### STANDARDS COMMITTEE MEETING

# APPROVED MI NUTES

## November 19, 2009 Standards Committee Meeting

701-BPIL-04 SPLICING PIPE PILES IN FIELD  
 (PROPOSED STANDARD DRAWING REVISION)

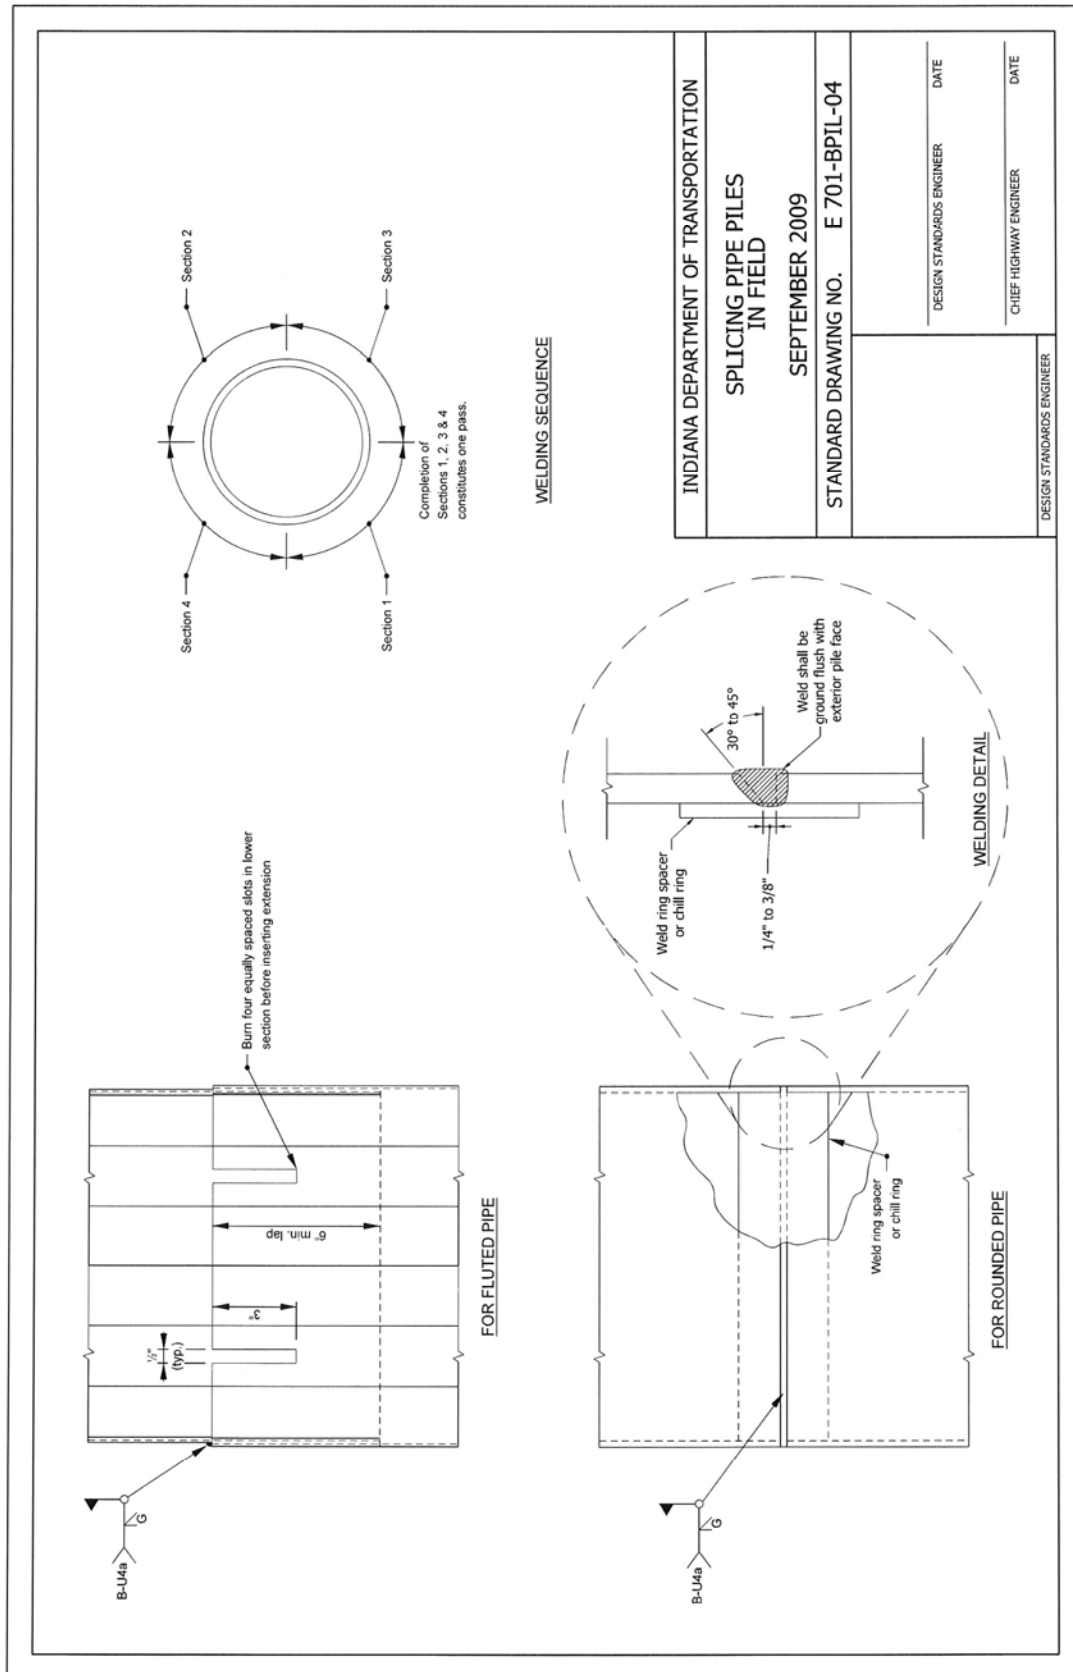
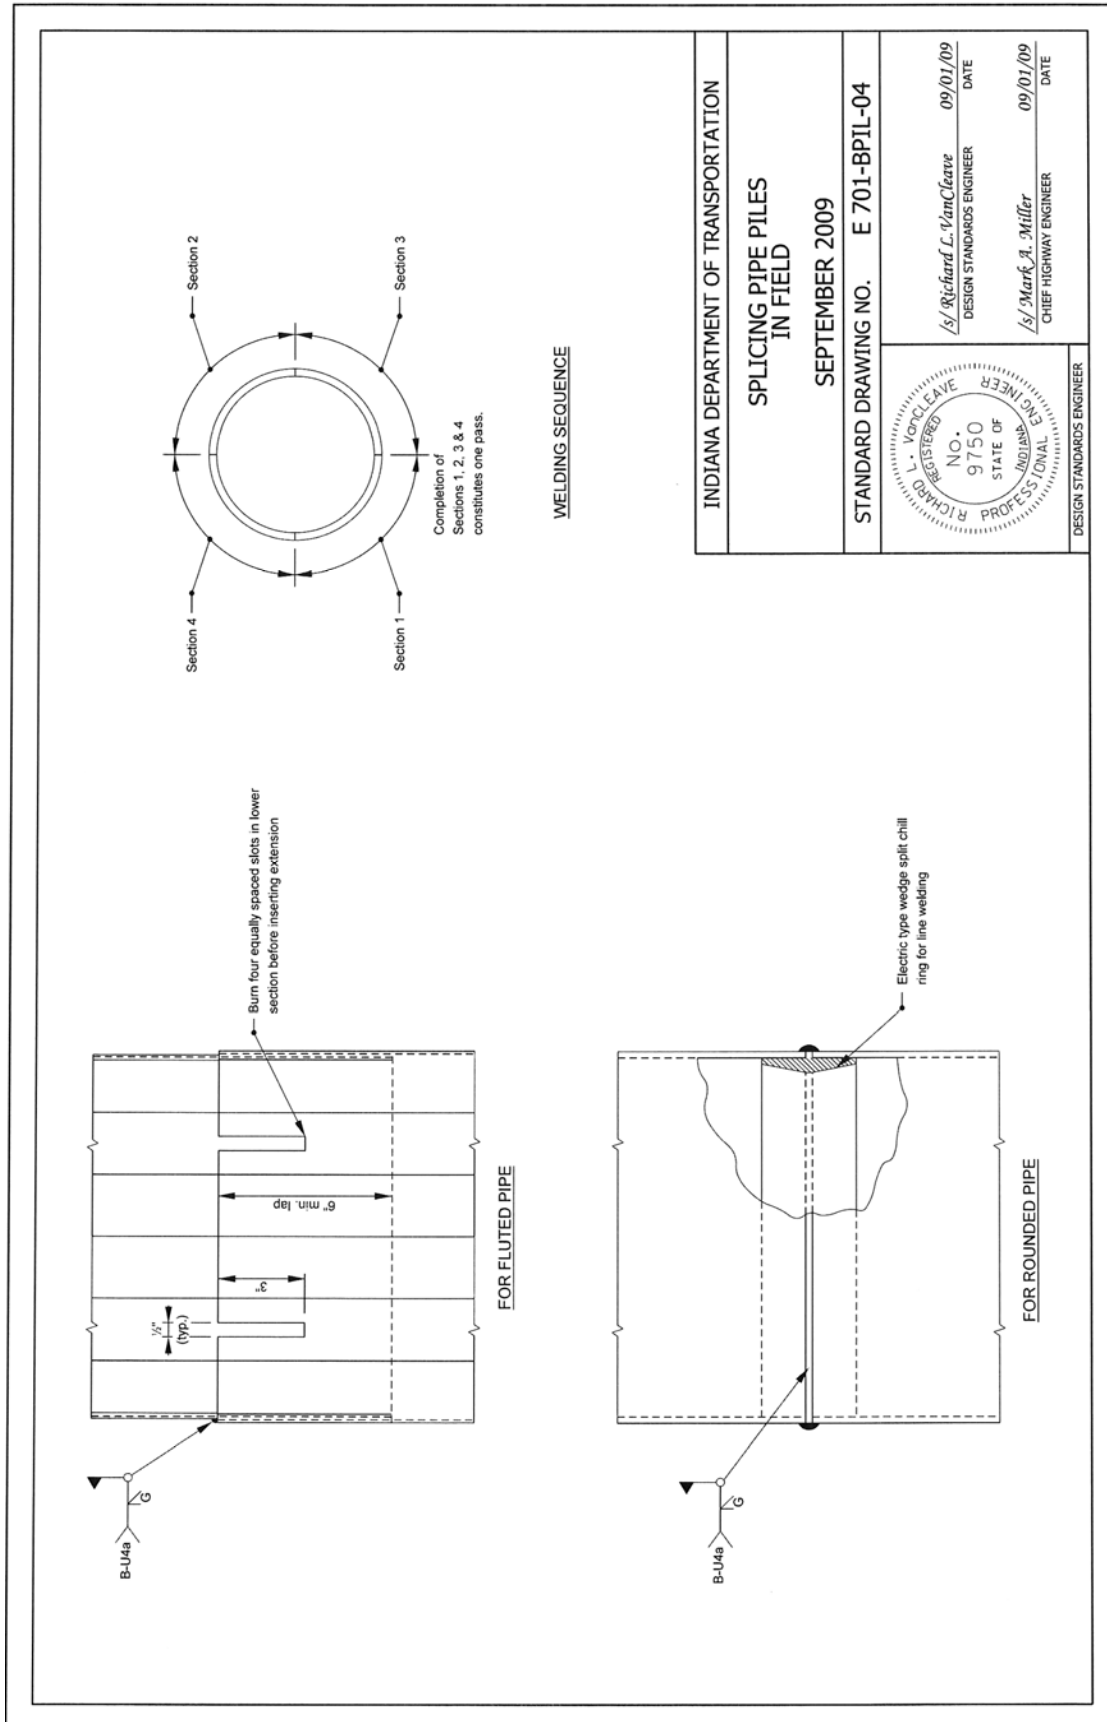
PROBLEM(S) ENCOUNTERED: The weld detail information on standard drawing 701-BPIL-04 is not clear. It is widely reported that the beveled edge is not being placed on the piling, nor is the gap being provided prior to welding. The lack of a beveled edge or gap between the piles may be a cause of recent welded splice failures.

PROPOSED SOLUTION: Add a "blown up" detail of the weld area showing the beveled edge on the upper pipe pile and the space that is supposed to be between the piles being spliced. Incorporating this detail on the Standard Drawing will help clarify the weld detail to the PE/S since very few individuals have knowledge of or access to the AWS Bridge Welding Code to know what the B-U4a weld symbol shown on the current drawing indicates or requires.
